**Pacific Sardine
Stock Assessment Review (STAR) Panel Meeting Report**

Southwest Fisheries Science Center (SWFSC),
National Oceanic and Atmospheric Administration (NOAA)
La Jolla, California
February 21-23, 2024

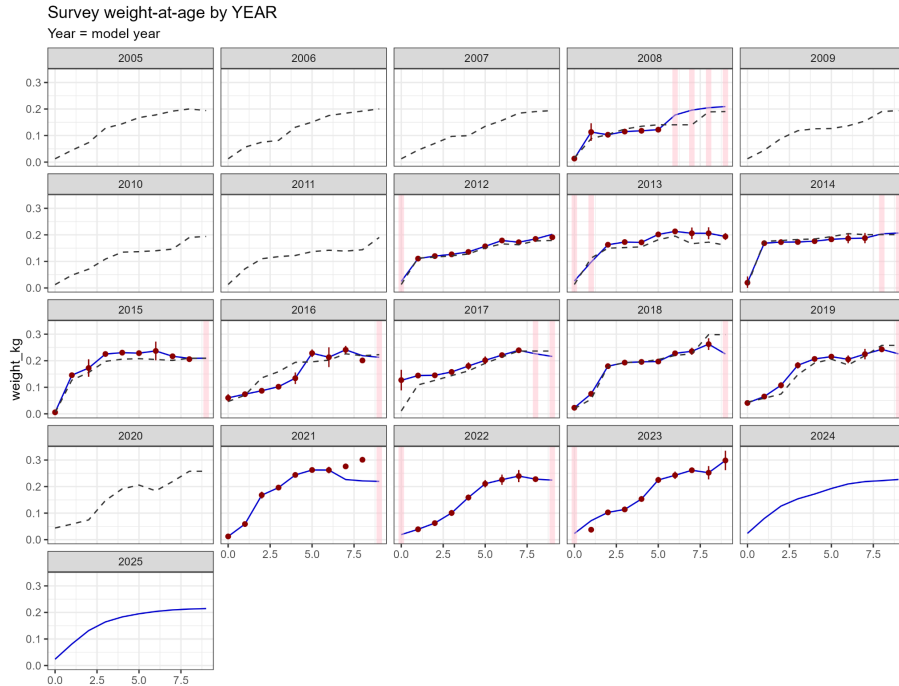
Request 3: Display the means and associated estimates of uncertainty (e.g., 95% confidence intervals) for the weight-at-age data that were used to fit growth curves (weight as a function of age) for each fleet. For Figs. 10.2-10.4, use red/salmon for raw data, blue/green for model-based estimates, and grey for imputed values. Also include estimates of uncertainty for forecasted values and ensure that the values in Table 10.3 match those in Fig. 10.1.

Rationale: The Panel noted that model-based estimates of weight-at-age differed from the weights-at-age used in the 2020 assessment, but some of those weights-at-age were imputed. Also, some of the data on weight-at-age used to fit the model were based on small sample sizes, which may explain why the model is unable to match all of the observations.

STAT Response: The following plot represents an example of those produced by the STAT. Imputed values were removed. Instead, years with missing data are shown as pink bars. The weights-at-age in the 2024 model are shown in blue, and those from the 2020 model are displayed as dashed lines. Estimates of uncertainty for forecasts are considered as part of Request 10. The need to ensure matching values between Table 10.3 and Fig. 10.1 is listed in Appendix 2.

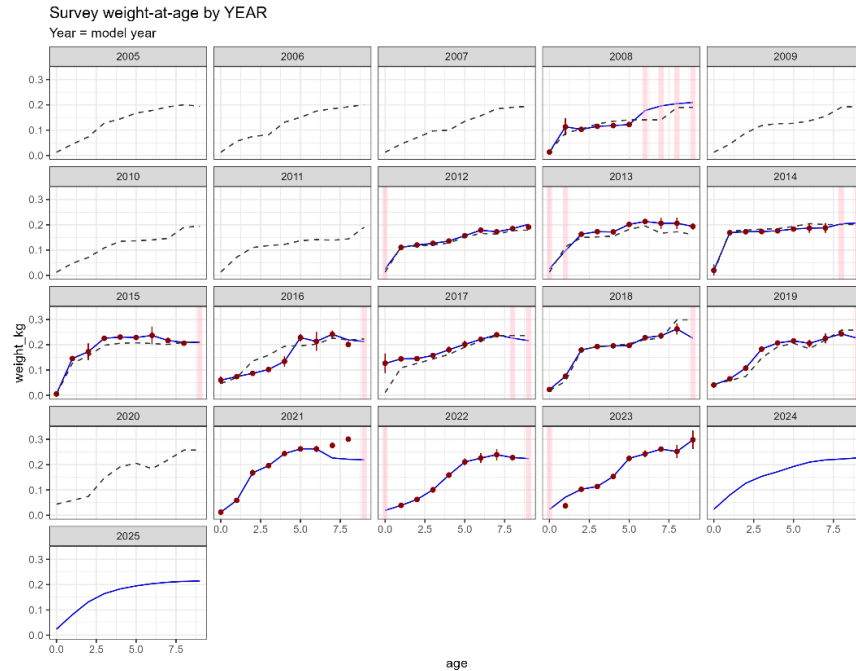
Request 4: Apply the model-based estimator to raw weight-at-age data from the survey rather than applying age-length keys.

Rationale: The model-based approach can provide estimates of weight-at-age for all years, which is important because survey-based weight-at-age estimates are assumed to be the population weights-at-age.

STAT Response: The STAT provided the requested figure. It suggested that the model-based approach leads to unrealistic values for weight-at-age. The weights-at-age in the 2020 assessment were based on applying age-length keys to length-frequency data. In contrast, the figure provided by the STAT was based only on aged individuals. However, the number of age samples is low relative to the number of length samples. There was no change to how weight-at-age is specified for the survey / population in the base model based on this request.

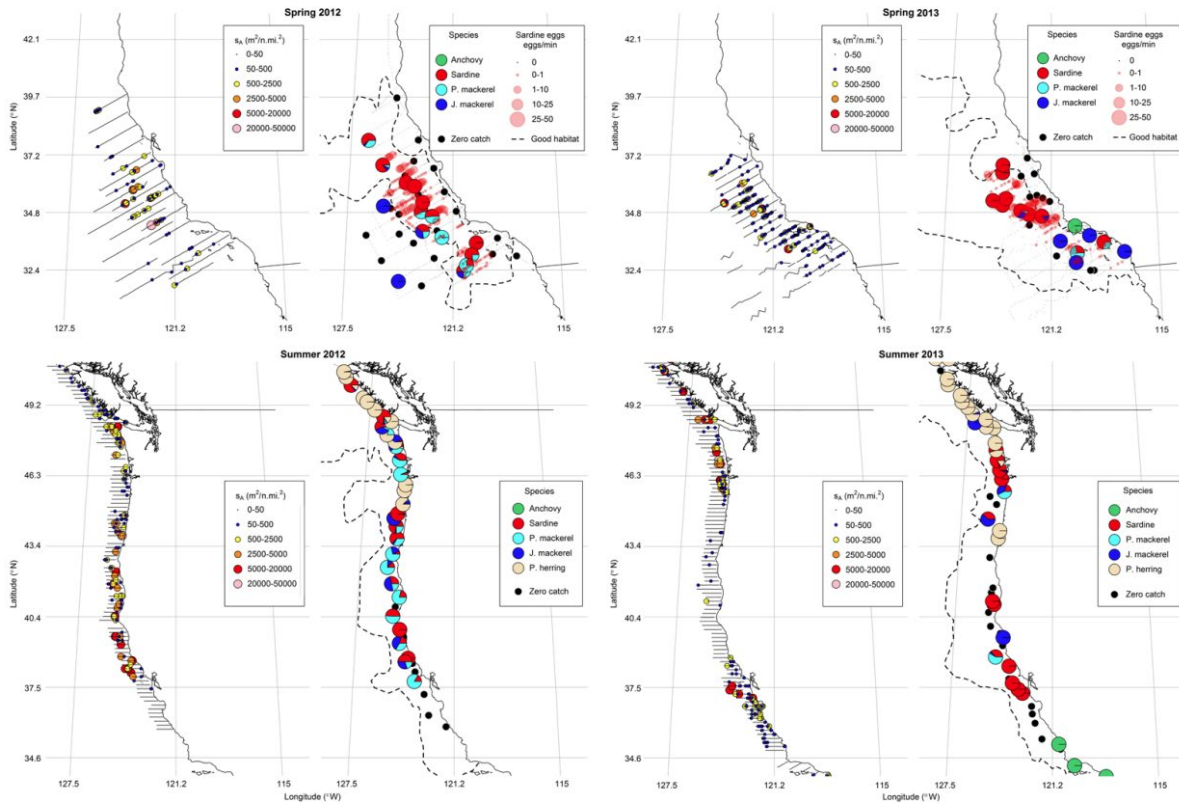
Request 5: Provide a figure that displays the spatial extent of the survey for years with greater biomass (e.g., 2005 and 2007).

Rationale: The spatial extent of the population likely varies with population size, but the STAT only provided plots for years with lower abundance.

STAT Response: The STAT presented the following figure (excerpt from Zwolinski *et al.*, 2014), thus confirming this assumption.

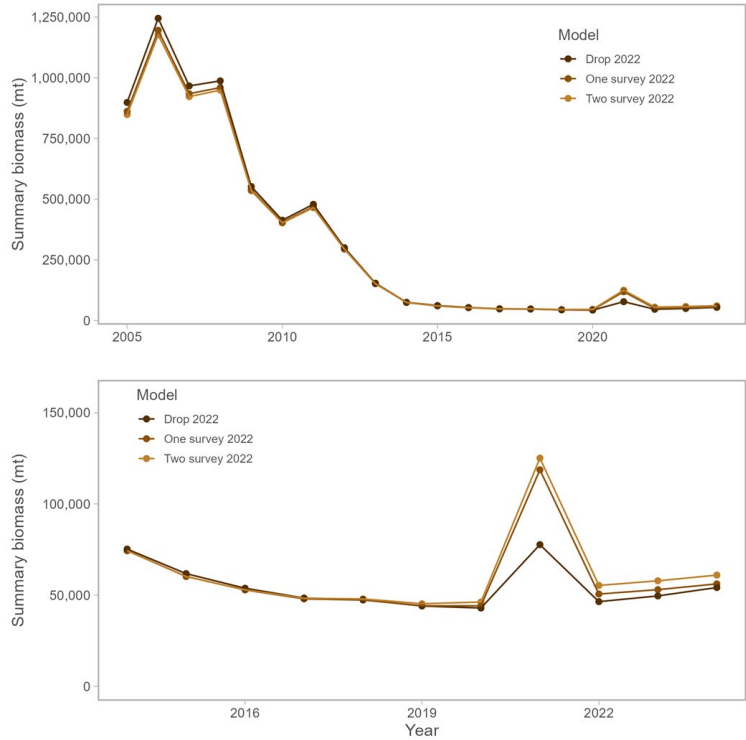
Request 6: Perform a sensitivity analysis in which the AT biomass estimate for 2022 is the total biomass estimate for the NSP and Q for the 2022 survey is set to 1. The survey age compositions for 2022 should equal the sum of the age compositions for *Lasker*+nearshore and for *Lisa Marie*.
Rationale: The Panel wished to understand if a simpler way of handling the 2022 survey data would lead to a different result.

STAT Response: The STAT presented results from combining the 2022 survey data and dropping the 2022 survey altogether. Combining the surveys resulted in slightly higher biomass after 2019. Dropping the 2022 survey had larger impacts. Combining the surveys simplifies model calculations and thus will be the approach used for the new base model. The STAT also corrected the CV for the 2023 survey estimate of biomass for this model run.

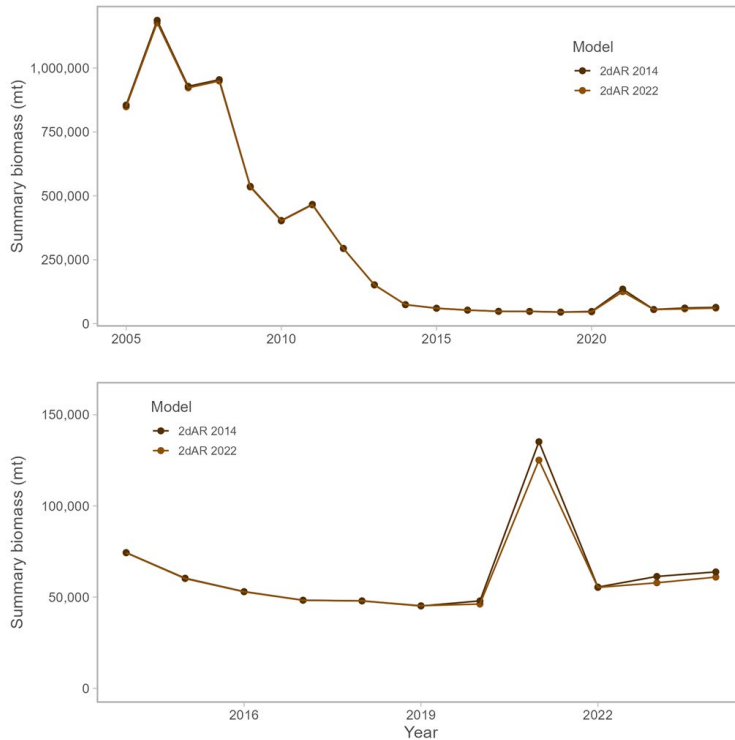
Request 7: Conduct a sensitivity analysis that stops using 2dAR as time-varying selectivity in 2014 (i.e., use base selectivity from 2015 to 2023).

Rationale: 2014 is the last year with decent age-composition data.

STAT Response: There were small effects of altering time-varying selectivity on model results. Ending 2dAR selectivity in 2014 and using base selectivity from 2015 to 2023 will form part of the new base model.

2022 Sardine Habitat

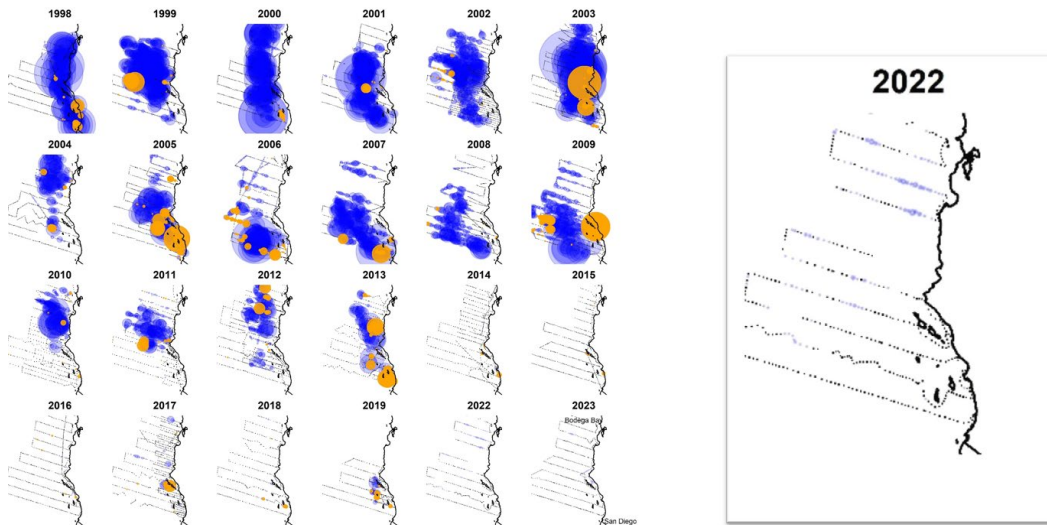
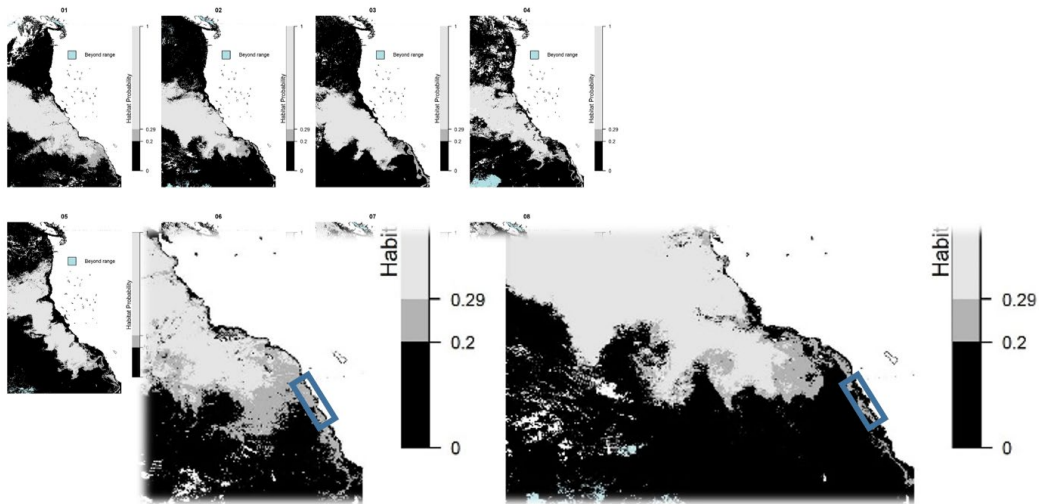
Request 8: Plot the geographic area used for the January 2022 catch estimate from Ensenada and color-code the covariates. Conduct a sensitivity analysis that removes the January 2022 catch estimate for Ensenada from the time series used in the assessment.

Rationale: This sensitivity analysis will elucidate potential impacts of the anomalous January 2022 catch estimate on model results.

STAT Response: Habitat maps for 2022 are shown below. There were higher sea surface temperatures recorded during winter 2022 (K. Hill, pers. comm.). Although potential sardine habitat was detected in January 2022, ancillary information showing that the northern stock has been practically absent from its southernmost distribution in the recent past, particularly in 2022 and 2023, provides support to removing the Ensenada catches. The sensitivity analysis of removing Ensenada catches in January 2022 is considered as part of Request 11.

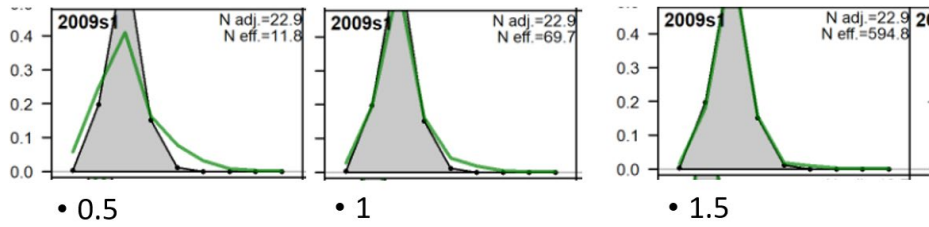
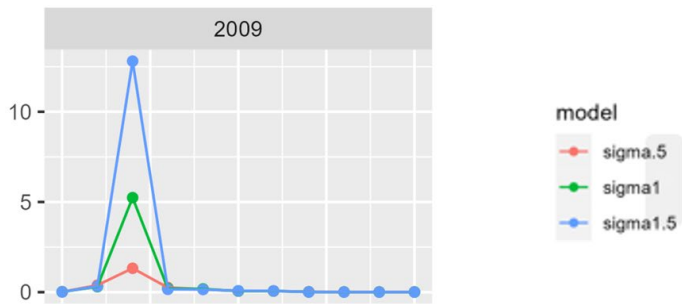
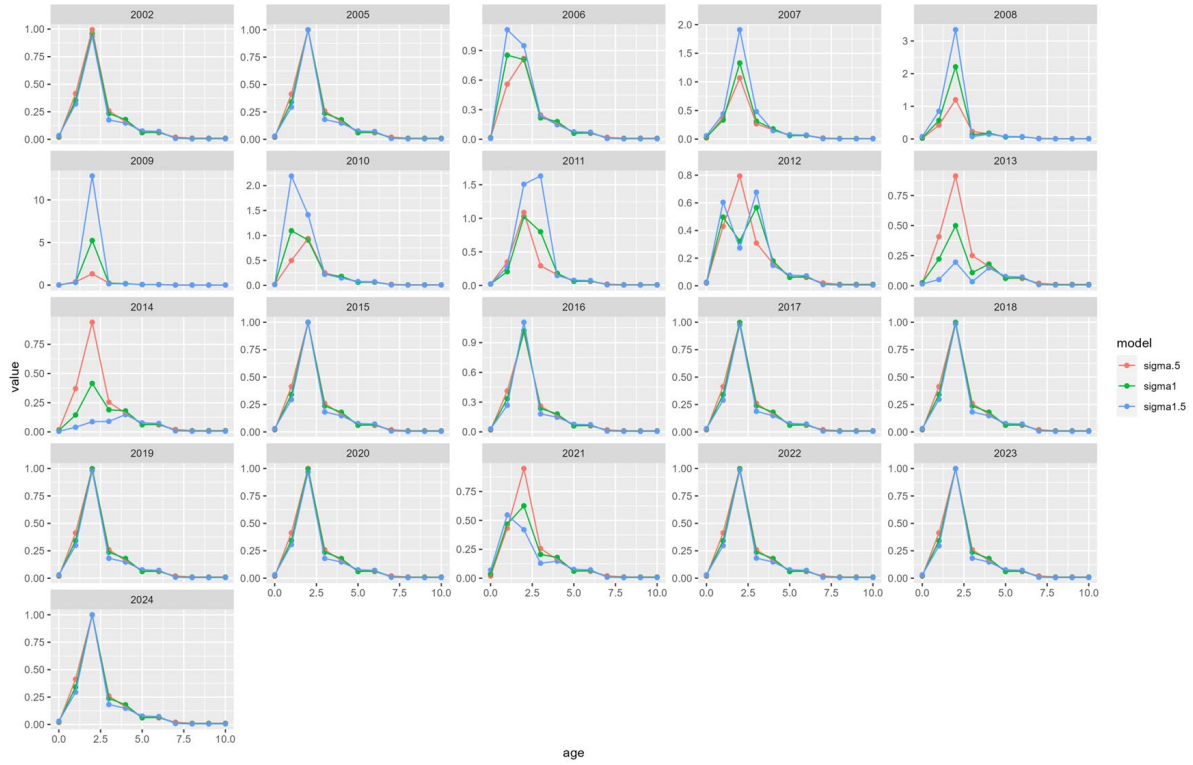
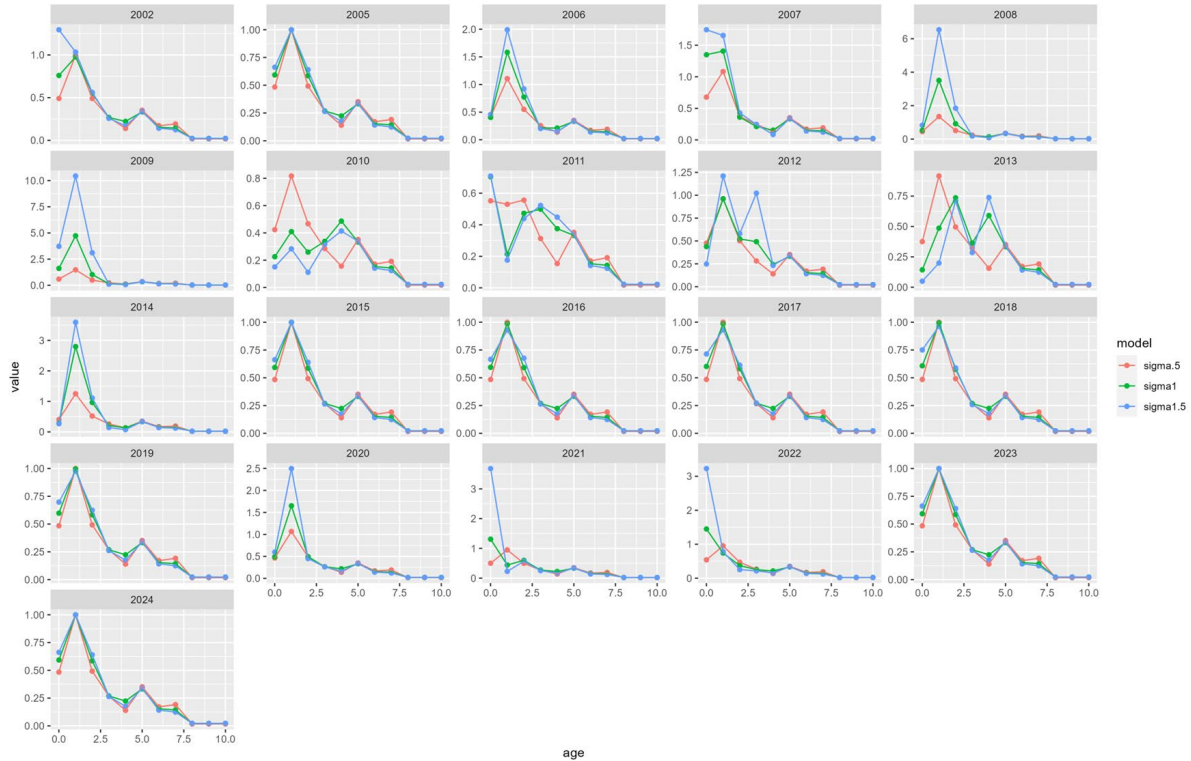
Request 9: Include a visual representation of model fits to age compositions, and selectivities for different levels of 2dAR sigma (based on the updated model).

Rationale: The Panel wished to understand how the value of sigma impacted the fit to the fishery and survey age composition data.

STAT Response: Below are examples of fits to age compositions at different levels of sigma (left = 0.5; center = 1.0; right = 1.5). Increasing sigma improved the fit to the fishery age compositions only marginally and did not noticeably improve the fits to the survey age compositions. The base model after the day 1 requests differed from the base model in the draft assessment report by setting h set to 0.7, using updated Pacific Northwest (PNW) catches, stopping 2dAR selectivity in 2014, summing the two 2022 survey estimates, and correcting the CV for the 2023 estimate of biomass. Following the day 2 requests (e.g., dropping Ensenada catch from January 2022), h was updated to 0.6.

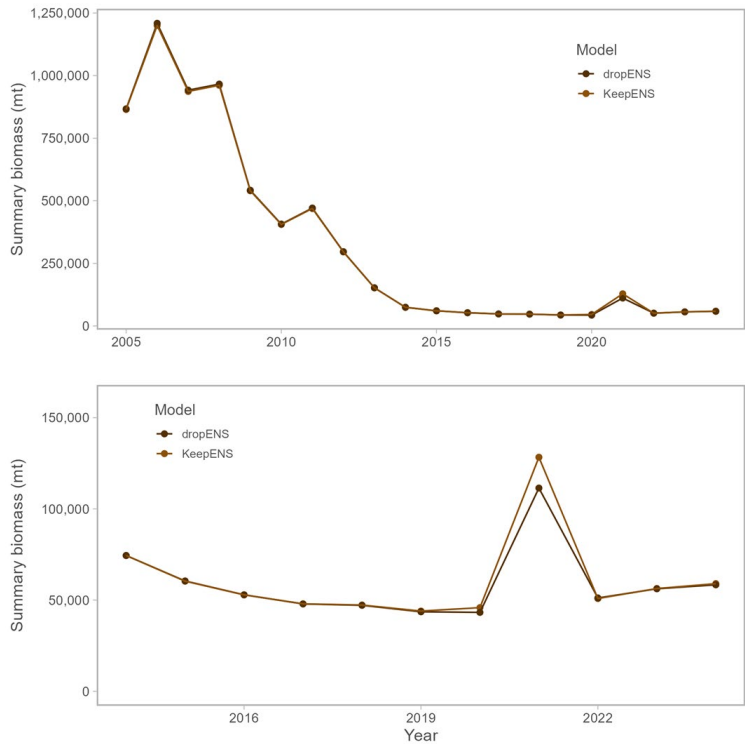
Request 11: Conduct a sensitivity analysis that removes the January 2022 catch for Ensenada from the time series.

Rationale: This sensitivity analysis will elucidate potential impacts of the anomalous January 2022 catch on model results.

STAT Response: The STAT dropped the catch data for January 2022 from the catch series used in the assessment because there is little support for the assumption that this catch should be attributed to the NSP. Although sardines are abundant along the Southern California Bight and off northern Baja year-round, those fish are exclusively nearshore and do not spawn in traditional NSP habitat. The original catch value was 11,172 mt and the STAT proposed replacing it with a value of 193 mt. The effect of excluding this catch on the trajectory of 1+ biomass was minor. This change was incorporated into the new base model.

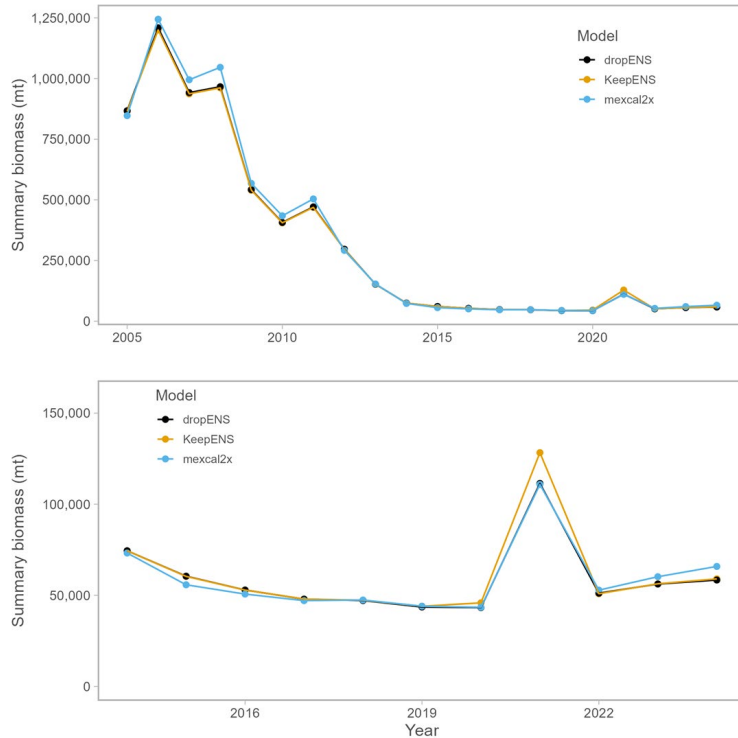
Request 12: Using the new base model, double the MexCal catches in both seasons.

Rationale: To understand the impacts of potential unaccounted removals due to illegal, unreported, and unregulated fishing (IUU) (Cisneros-Montemayor *et al.*, 2013) and increased uncertainty in Mexico catches. This sensitivity test is more extreme than simply doubling the catches off Ensenada.

STAT Response: Doubling the MexCal catches had minor impacts on age 1+ biomass.
